REMARKS

DRAWING OBJECTIONS

Figure 7

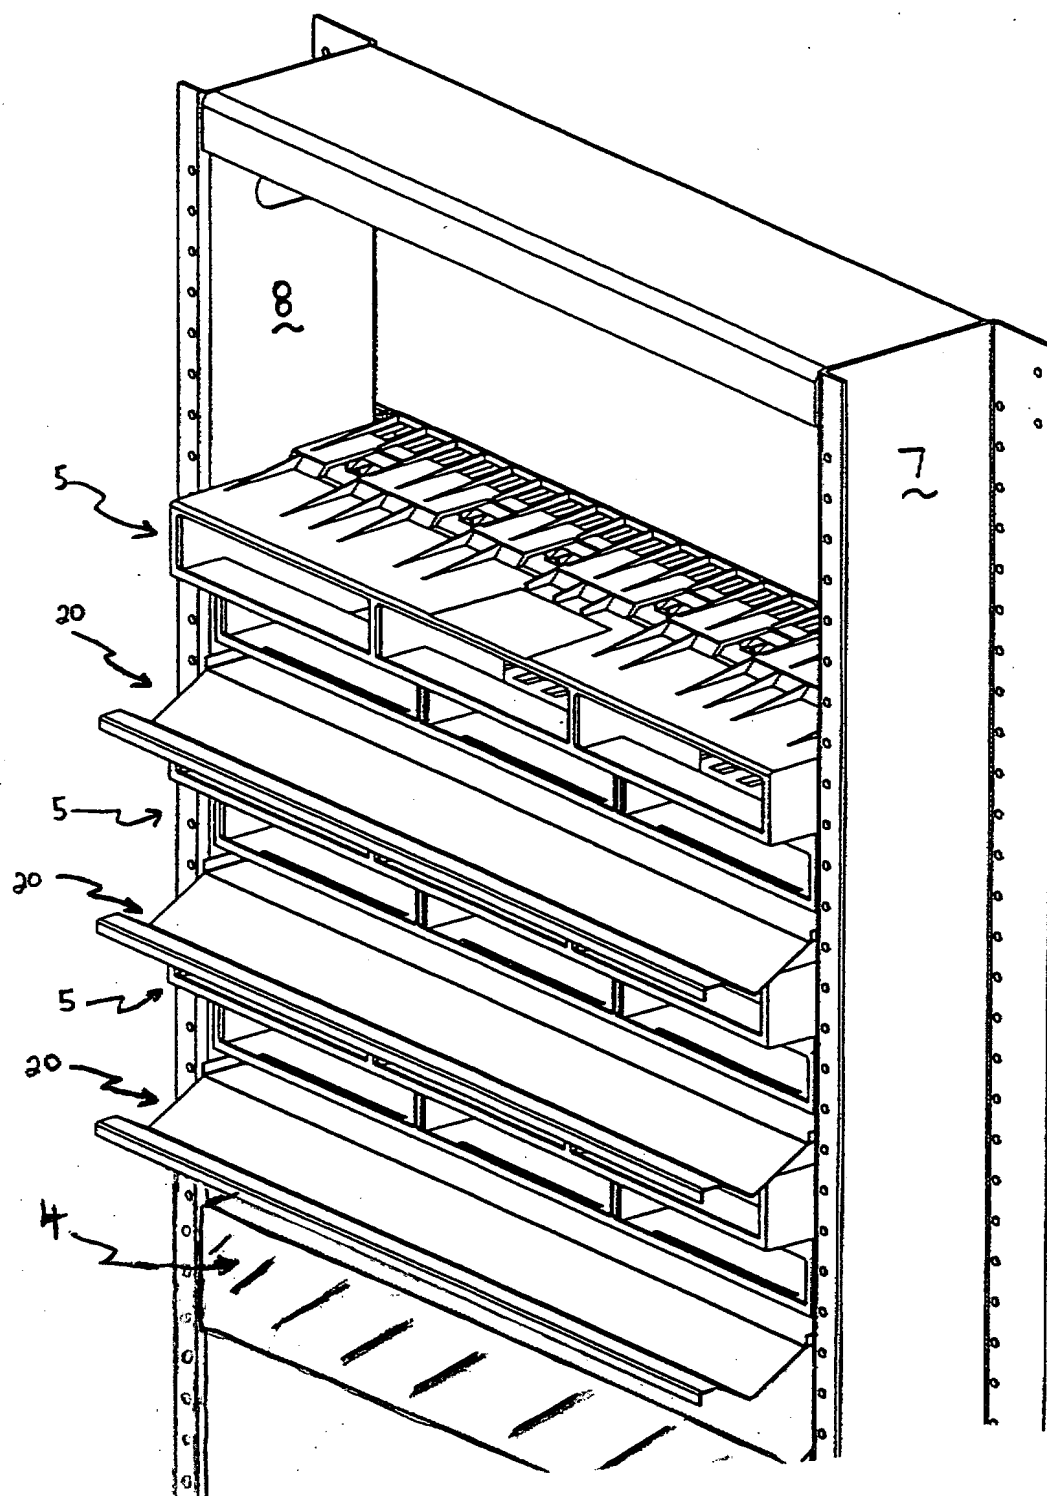
The Examiner has objected to the drawings as failing to illustrate a power supply, as described in the specification. The Examiner states that any structural detail that is essential for a proper understanding of the disclosed invention should be shown in the drawings.

In any event, Applicants submit herewith a proposed drawing correction to Fig. 7. In Fig. 7, a block representation of a power supply 4 has been illustrated in combination with the flame shield 20 in accordance with the present invention.
